Forty's Pitch

***Road Safety Audit Response Report***

**Stage 1 Road Safety Audit**

**Site Access Arrangements and Pedestrian Crossing**

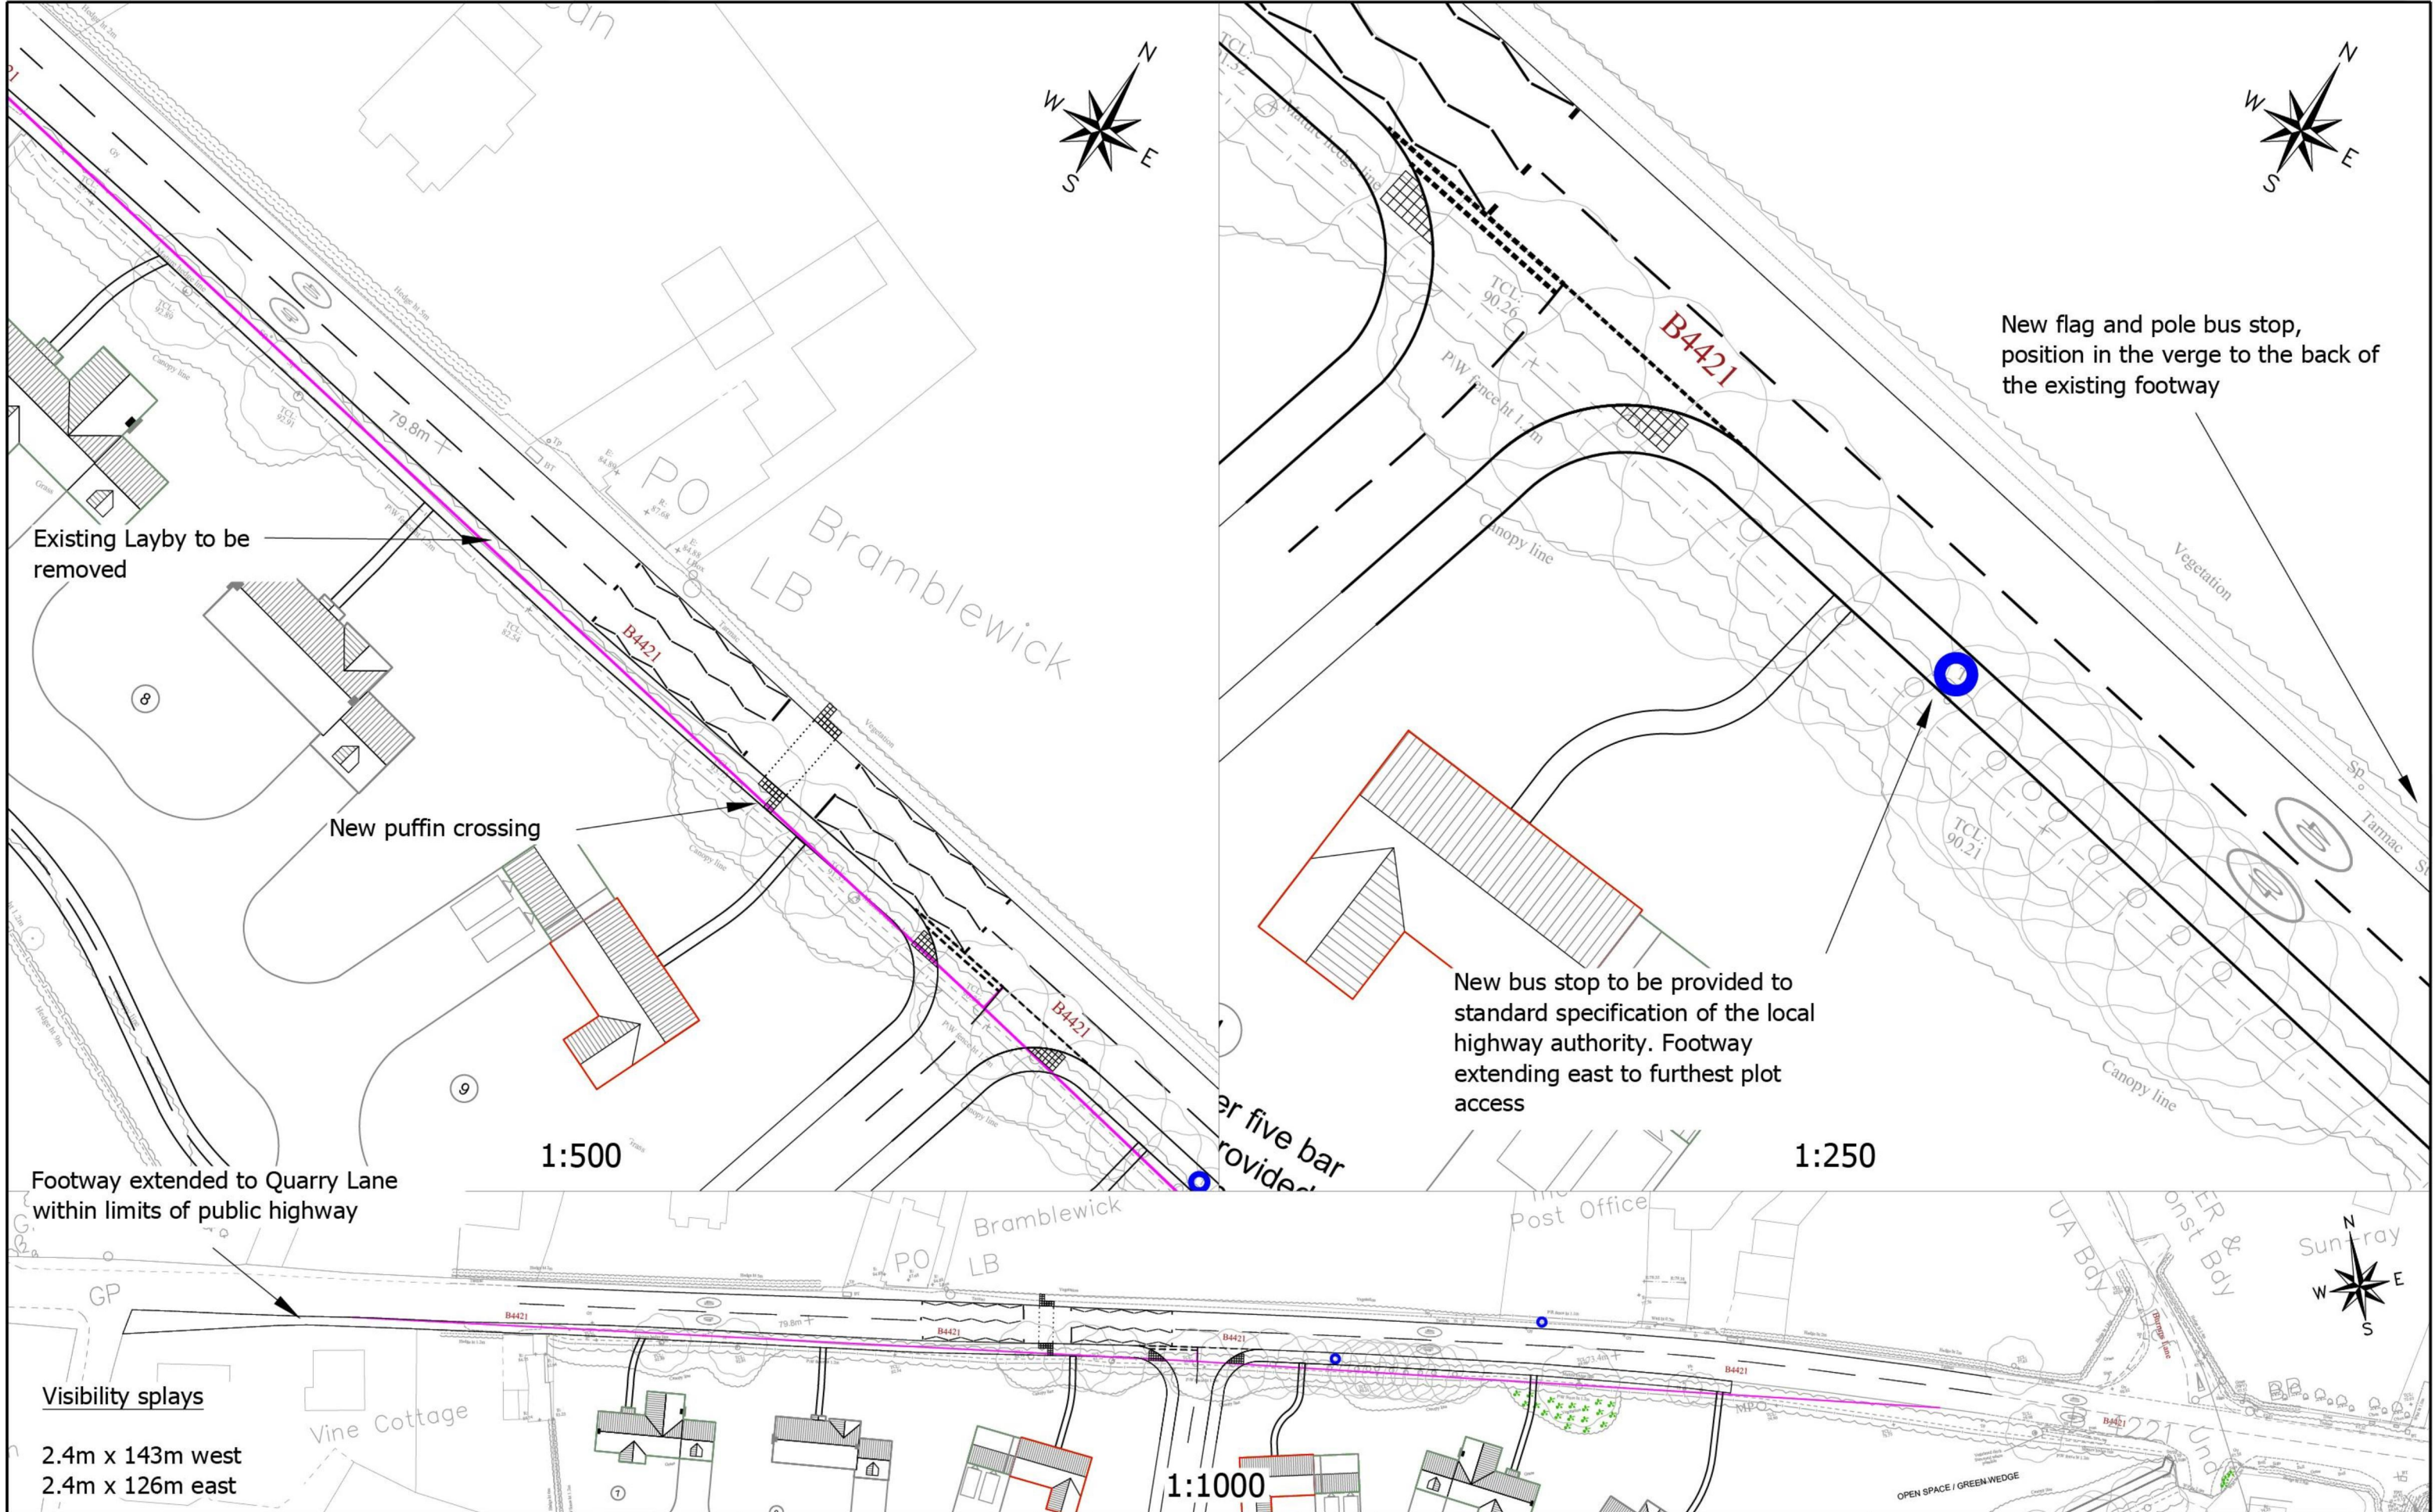
Two bus stops are proposed, to the east of the proposed development access. The orientation of the bus stops may lead to the carriageway being blocked, should buses occupy opposing stops at the same time; this may lead to late braking nose to tail collisions.

It is recommended that the bus stops are relocated to maximise the use of the proposed crossing – tail to tail configurations are considered conventional, with a separation of three bus lengths.

*The southbound bus stop has been relocated to change the stagger with an approximate separation distance of 35m. This is shown on **Drawing 16251-11b**.*

***Drawing 16251-11b** shows tactile dropped kerb crossing facilities across the site access junction.*

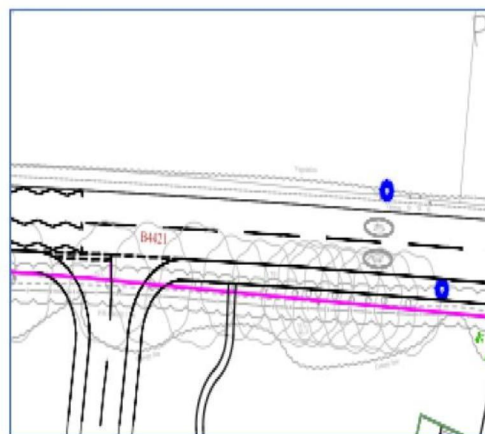
Off-peak vehicle speeds are shown to be in excess of the posted 40mph speed limit. Drivers attempting to stop at the signals may overshoot the stop line, particularly in wet weather conditions. This may lead to failure to stop type pedestrian to vehicle collisions.

It is recommended that the signals installation be provided with appropriate speed assessment / discrimination equipment (or MOVA installation) (reference Table 2 LTN 2-95). Appropriately specified skid resistant surfacing should be provided to ensure braking vehicles.

*The recommendation is generally accepted however, precise details will be discussed agreed with the LHA during the delivery of the crossing.*

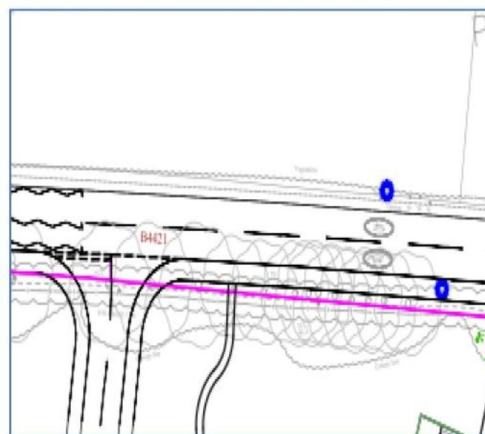
Two bus stops are proposed, to the east of the proposed development access. Pedestrians are unlikely to use the signalled crossing, away from the direct pedestrian desire line, to access these stops. Pedestrians may be vulnerable to being struck by vehicles as they attempt to cross on the likely desire line.

It is recommended that the bus stops are relocated to maximise the use of the proposed crossing.

*The bus stops are located at a point equidistant between the existing stops on the B4221, which has been agreed in principle with the operator. The crossing has been located on the crest of the hill to maximise the visibility for approaching drivers, it is therefore, not recommended that the crossing be relocated.*

*A simple dropped kerb crossing could also be provided to assist with crossing the road. See response to 2.6 below for appropriateness of a simple crossing.*

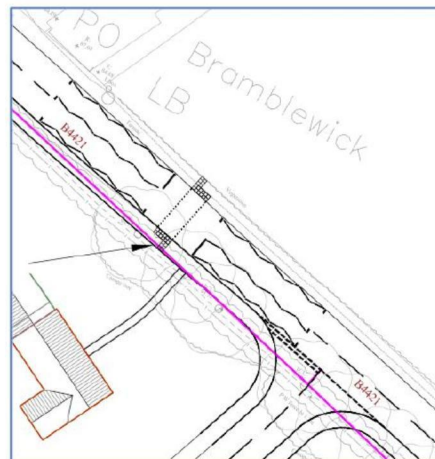
At the development access, no dropped kerb crossing facilities are indicated for pedestrians. Some users may have difficulty negotiating full height kerbs and this may result in pedestrian trips or falls.

It is recommended that appropriate dropped kerb crossing facilities are provided, with tactile paving to highlight the presence of flush kerbing.

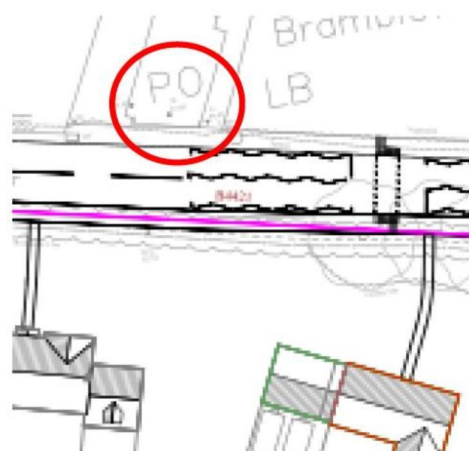
The proposed development consists of only nine residential properties; this level of development is unlikely to generate substantial levels of pedestrian activity and with low levels of existing development there may be a low frequency of operation of the crossing. Regular drivers of Forty's Pitch may not expect the operation of the crossing and this may lead to failure to stop type incidents (reference LTN 1-95 paragraph 4.2.4).

It is recommended that an assessment of need for the crossing is carried out. Other forms of pedestrian crossings, such as pedestrian refuges may be more appropriate.

*Information provided to Herefordshire in the form of a PV<sup>2</sup> calculation clearly demonstrates that a formalised crossing facility is not required, either in the form of a puffin or central refuge.*

*Using robust assumptions there is still no need for a crossing. We have assumed 25% of all residents are elderly; 25% are unaccompanied children; 25% have a pushchair; and it takes more than 60 seconds to cross the road. All of which are highly unlikely to be the case.*

*Finally, the road is not wide enough to be able to provide a refuge. Therefore, the road would need to be widened to provide a refuge, which could lead to increasing vehicle speeds.*
